MILITARY SPECIFICATION

INDICATOR, AZIMUTH-ELEVATION-RANGE IP-446/APG-53A

This amendment forms a part of Military Specification MIL-I-22231(AER) dated 30 October 1959 and has been approved by the Bureau of Naval Weapons, Department of the Navy.

Figure 3. Case dimensions.

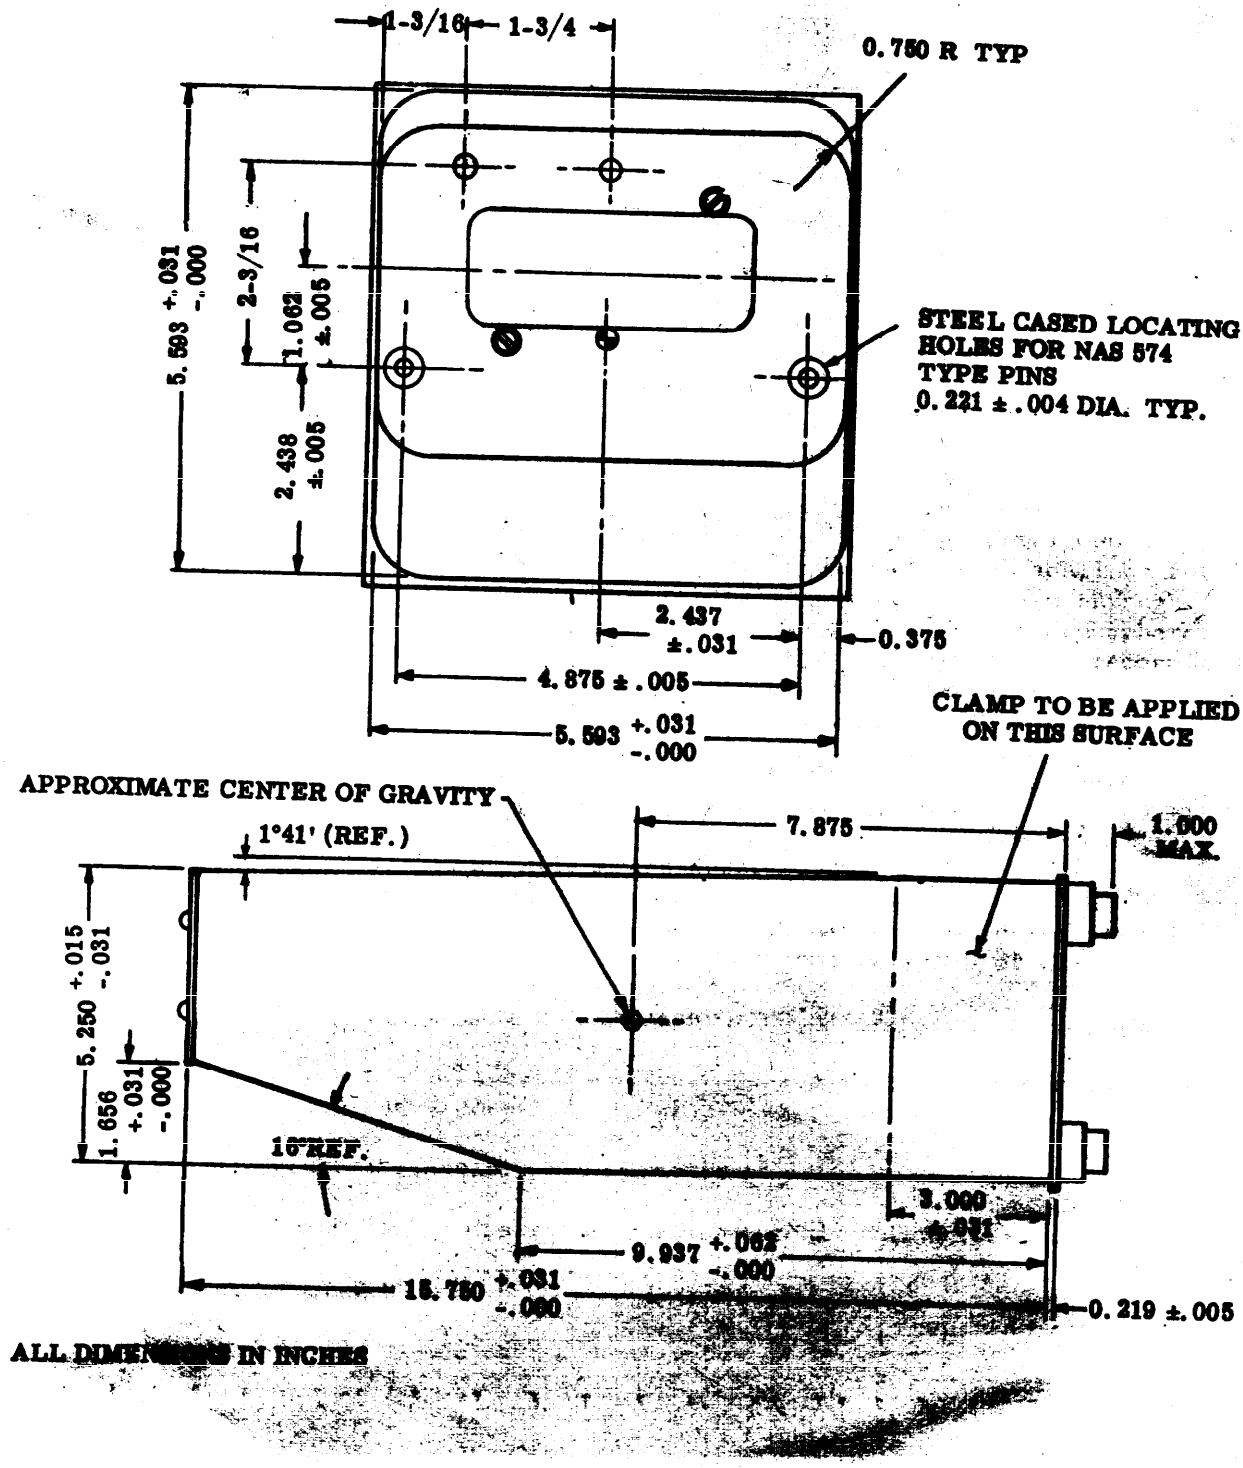
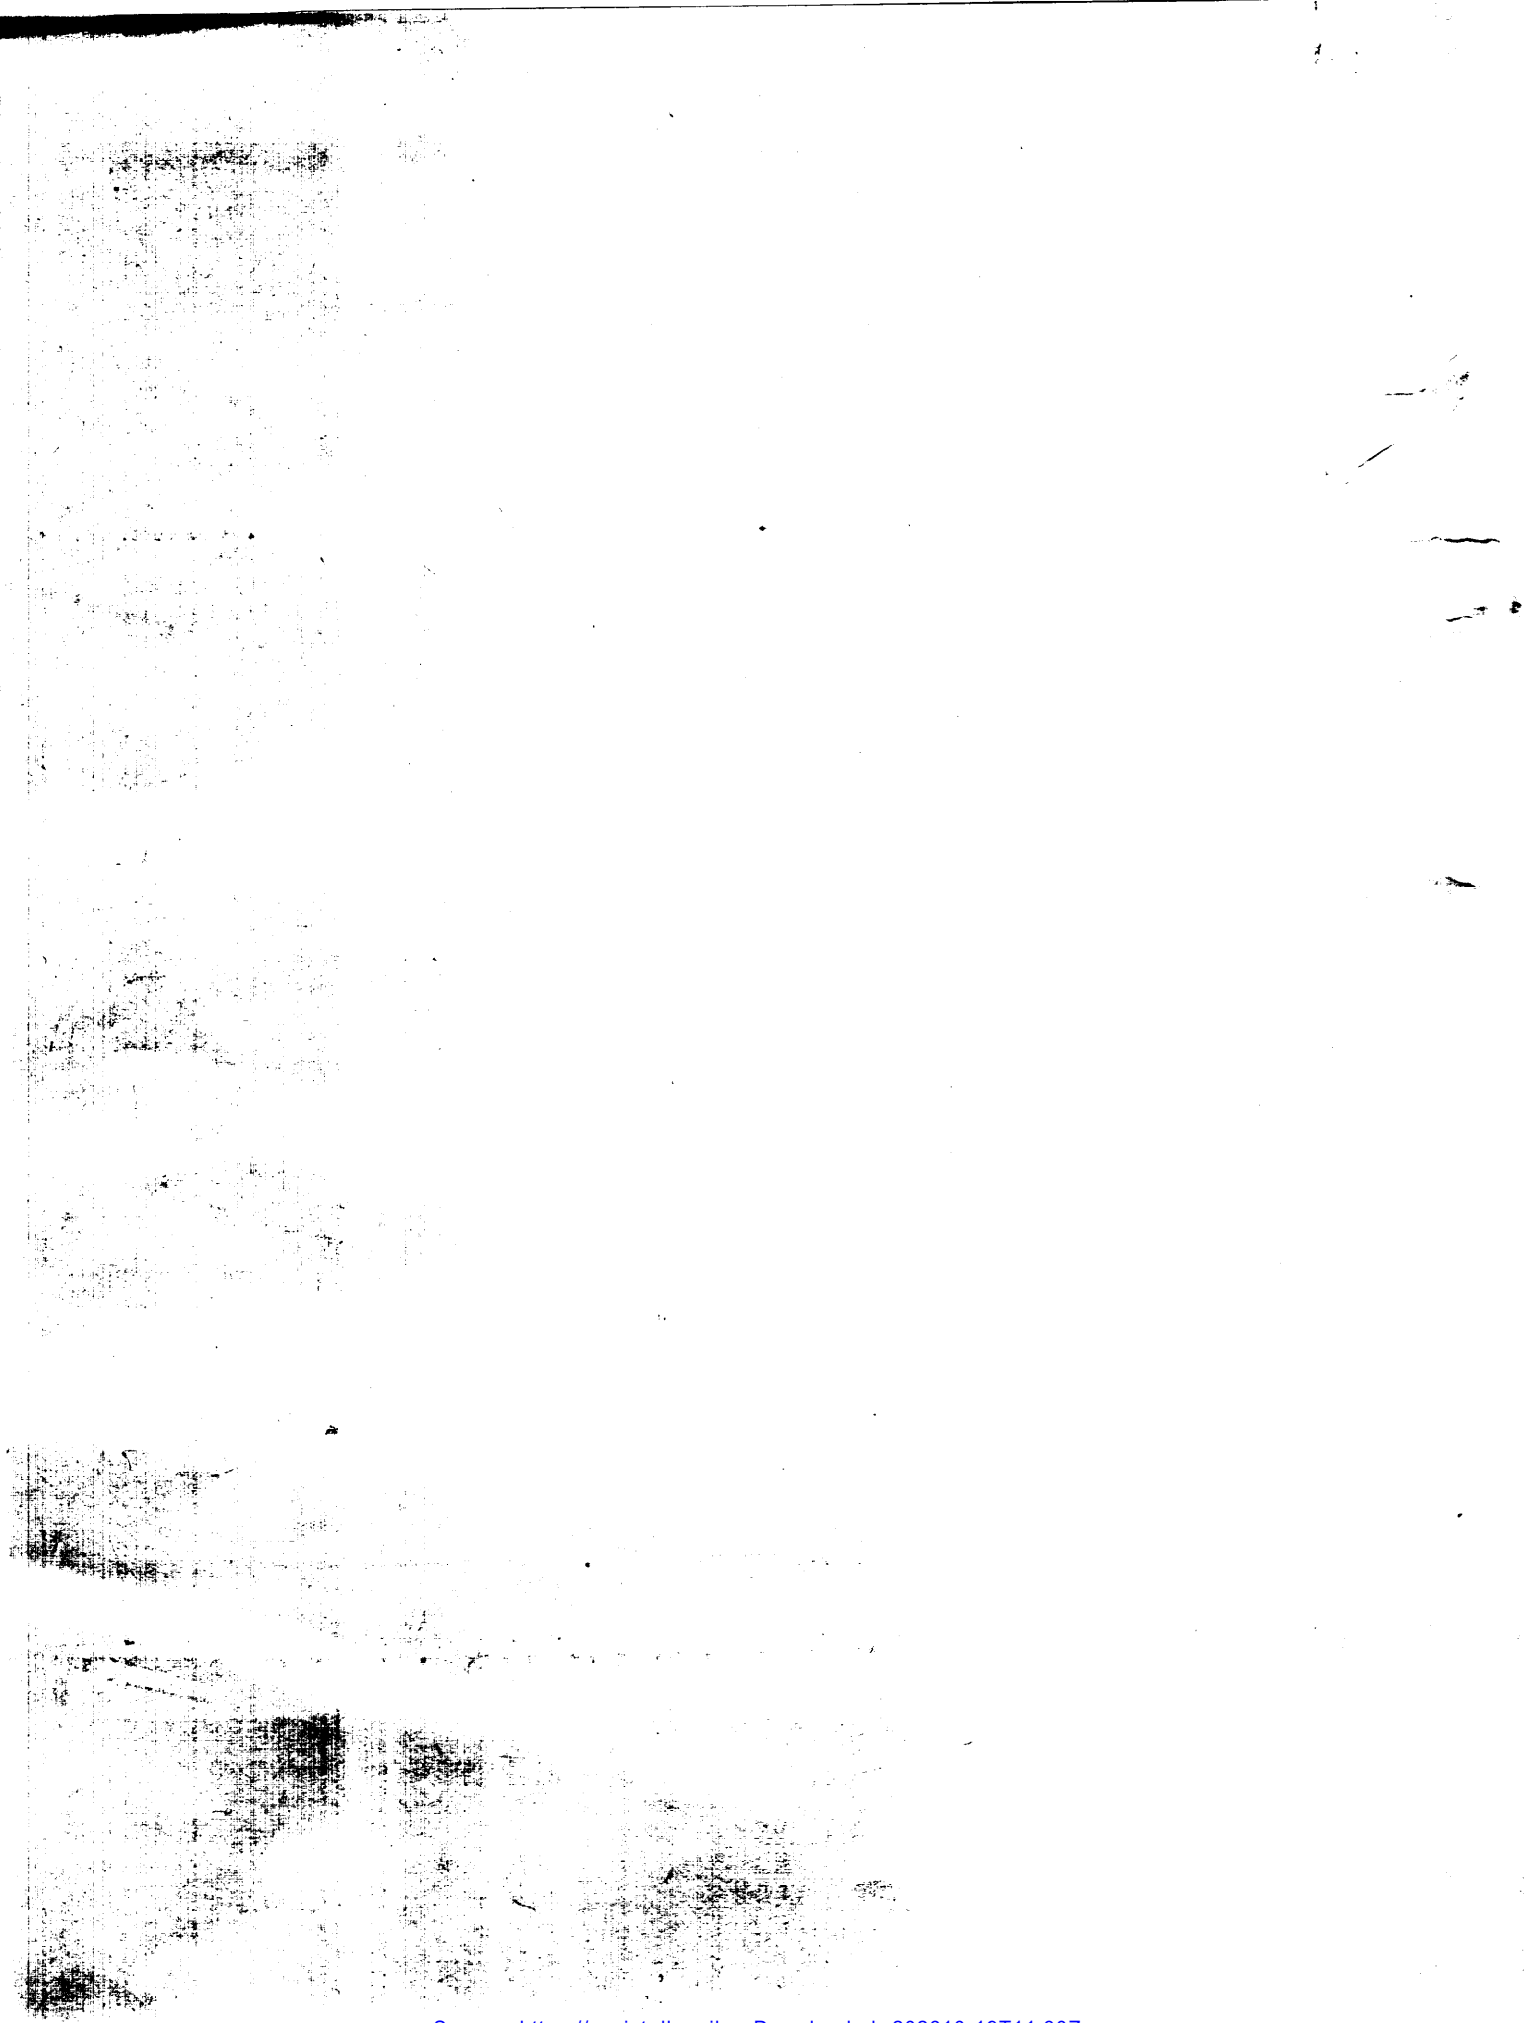
Figure 3: Delete and substitute new figure 3.
